Access Compliance Report

Public Rights-of-Way (Curb Ramps)

Intersection ID: 30294	Main Street: ELSBERRY_LN	Cross Street: RAVANNA_DR	Location:	N
ADA ID: F012B4CDCFBE	Ramp Type: PerpDiag	Initial Pass/Fail: Fail	Overall Compliance: No	Severity Score: 25

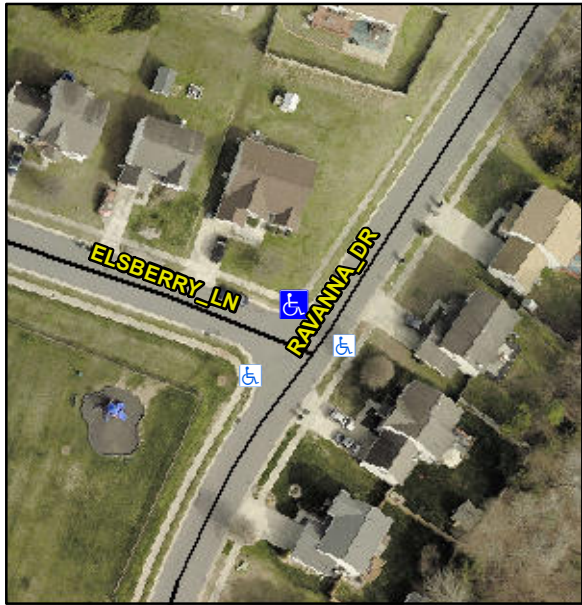
Codes/Mitigation Info/Possible Solution			Field Measurements/Component Compliance					
	Possible Solutions:		Compliance	Description	Data	Compliance	Description	Data
	Remove & Replace Curb Ramp With Two New Directional Ramps or Equivalent.		N/A	Ramp Length (in)	47.0	Yes	Ramp Slope (%)	6.0
			Yes	Ramp Width (in)	48.0	No	Ramp XSlope (%)	14.1
			N/A	Flare Type LT	N/A	N/A	Flare Type RT	N/A
			N/A	Flare Slope LT (%)	N/A	N/A	Flare Slope RT (%)	N/A
			N/A	Flare Traversable LT?	N/A	N/A	Flare Traversable RT?	N/A
			N/A	Landing Length (in)	N/A	N/A	DWS Provided?	N/A
			N/A	Landing Width (in)	N/A	N/A	DWS Contrast?	N/A
			N/A	Landing Slope (%)	N/A	N/A	DWS Length (in)	N/A
			N/A	Landing X Slope (%)	N/A	N/A	DWS Full Width?	N/A
Surveyor Notes:		N/A	N/A	Landing Curb? (Y/N)	N/A	N/A	DWS Offset (in)	N/A
PROW/ADA:		Not Found, R304.5.3	N/A	Shared Landing?	N/A			
			N/A	Gutter Ponding?	N/A	N/A	Gutter Slope (%)	N/A
			N/A	Gutter Lip Ht (in)	N/A	N/A	Gutter X Slope (%)	N/A

N/A	Painted X Walk1?	No	N/A	Painted X Walk2?	No
				X Walk 1 Direction	To W		X Walk 2 Direction	To E
			N/A	X Walk 1 Width (in)	N/A	N/A	X Walk 2 Width (in)	N/A
				X Walk 1 Slope (%)	8.4		X Walk 2 Slope (%)	2.0
				X Walk 1 X Slope (%)	3.9		X Walk 2 X Slope (%)	10.2
			N/A	Ramp inside XWalk1?	N/A	N/A	Ramp inside XWalk2?	N/A
				Road Slope (%)	7.5	N/A	Clear Space?	N/A
				Road X Slope (%)	4.2	N/A	Clear Space to XWalk (in)	N/A
			N/A	Any Obstructions?	N/A	N/A	Storm Grate/Utility Hazard?	N/A
				Obstruction Type			Storm Grate/Utility Type	
					N/A			N/A
						Yes	Surface Condition? (G/P)	Good
Street 1 Name		ELSBERRY LN						
Stop Condition-Street 2		StopSign						
Street 2 Name		RAVANNA DR						
Stop Condition-Street 1		None						
Total Cost:		\$ 3200.00
